City of Richmond
Urban Development Division

Report to Development Permit Panel

To: Development Permit Panel
From: Joe Erceg
Manager, Development Applications
Date: January 31, 2003
File: DP 02-212789
Re: **Application by Am-Pri Construction Ltd. for a Development Permit at
8080 Bennett Road**

BUILDING NO. 3
WEST ELEVATION
SCALE: 1/8" = 1'-0"

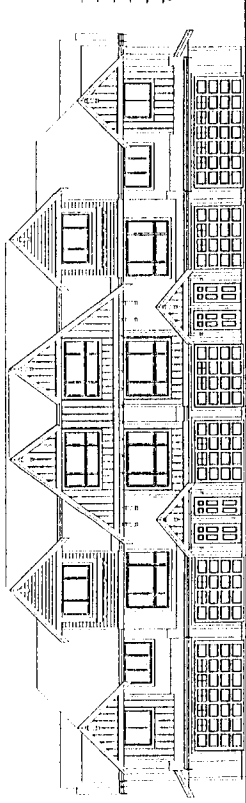
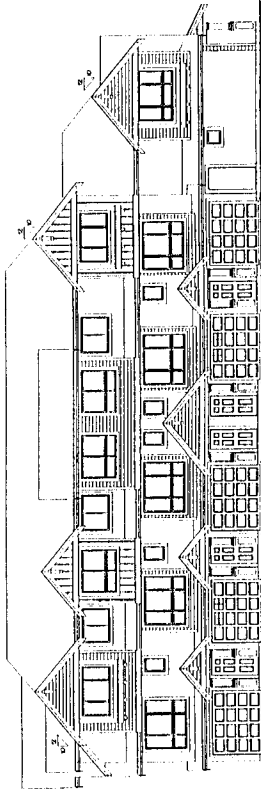
Improve the facades of Building 3, especially the sides facing the walkway and Bennett Road. There seems to be too many garage doors all the same, and the front doors could use more emphasis. Provide a more detailed landscape plan of the walkway and its amenities, lighting, etc.

The applicants have revised the plans accordingly, except that access was not added to the rear of the buildings because the floor plan did not lend itself to such a change, and it would lessen the private yard space.

RECYCL ENCLOSURE PLAN
SCALE 1/8" = 1'-0"

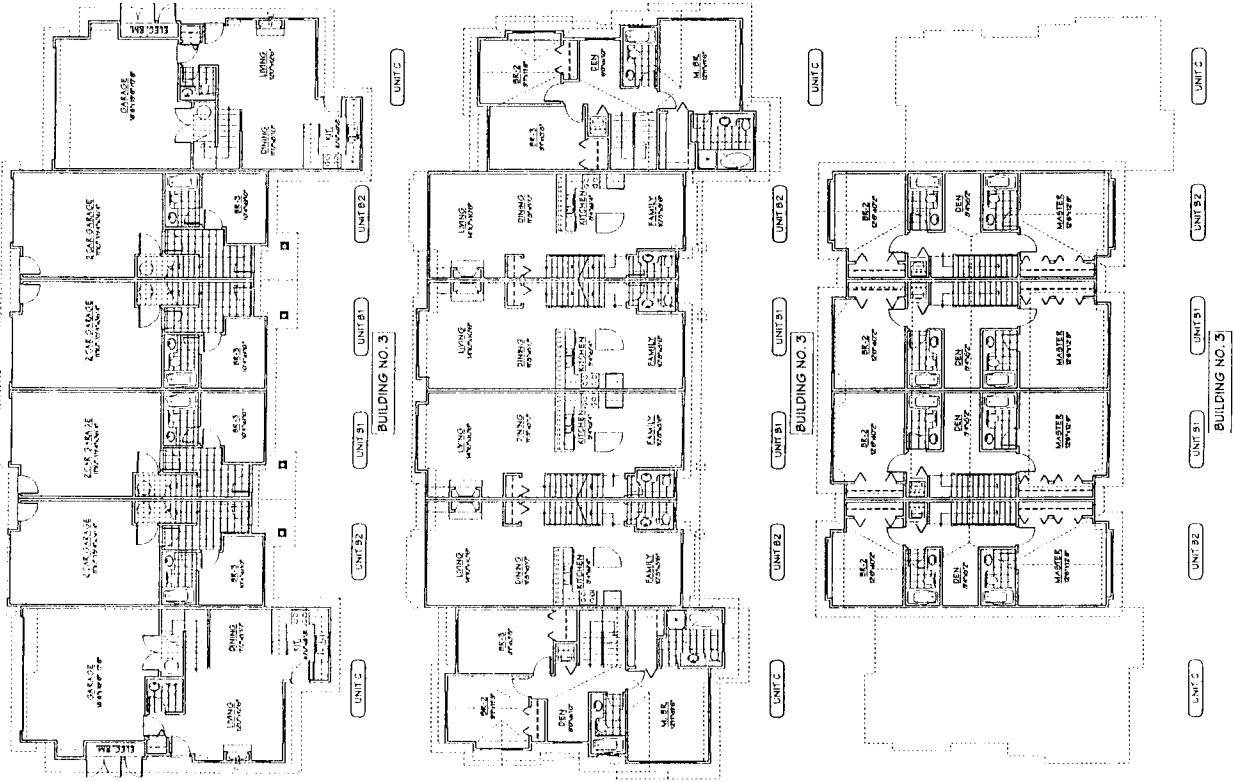
This development will be on private garbage collection and can apply to the City for City garbage collection (see Garbage Bylaw). The proposed location for the recycling enclosure is good. Please add space for a 3 cu. yd. cardboard recycling container and ensure the enclosure is 10 ft. away from combustible building.

The applicants have revised the plans accordingly.

FLOOR PLANS
BUILDING NO. 7 AND NO. 8

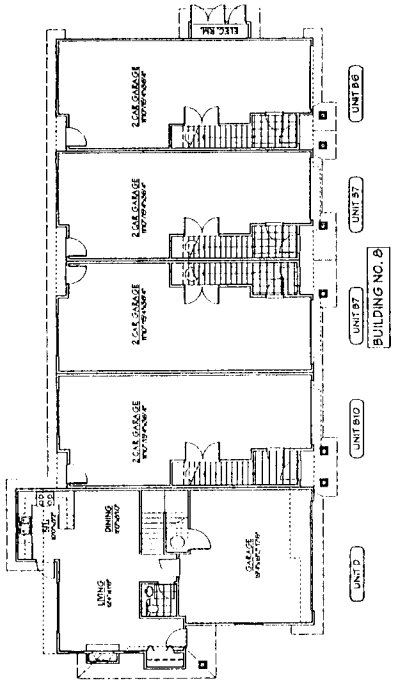
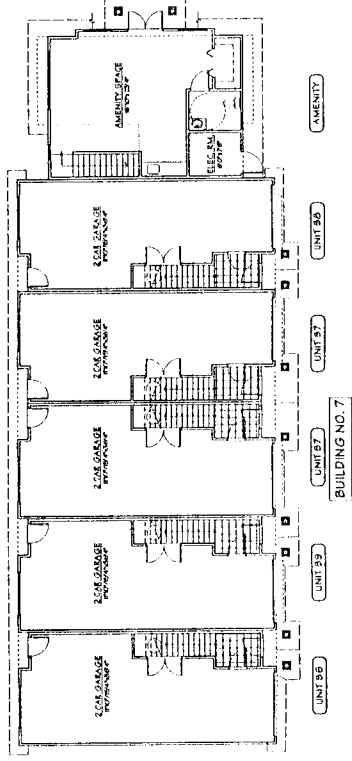
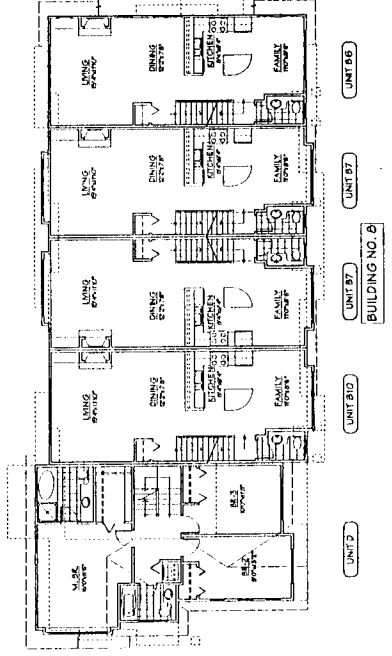
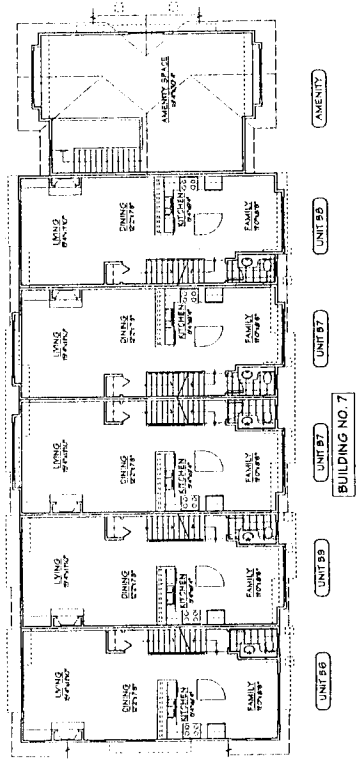
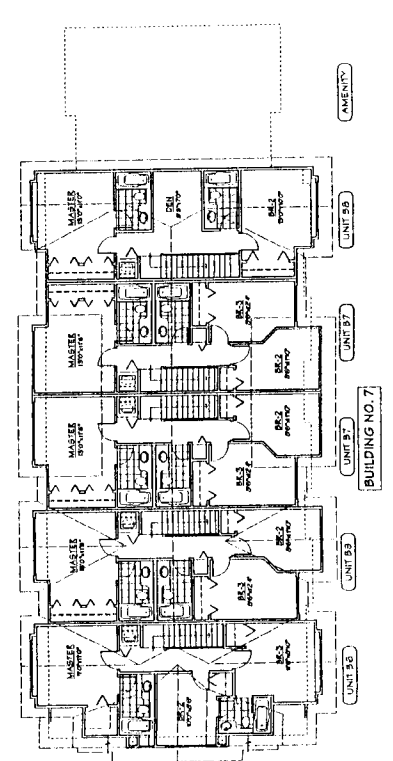
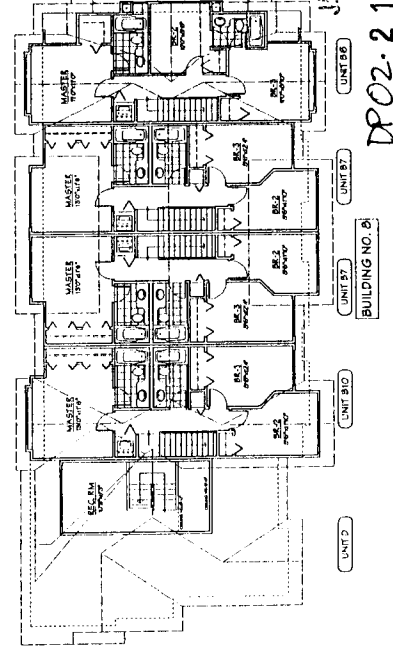
Buildings 7 and 8 should have access to the amenity space via the rear of the buildings. The architecture in general could use more character and better detailing.
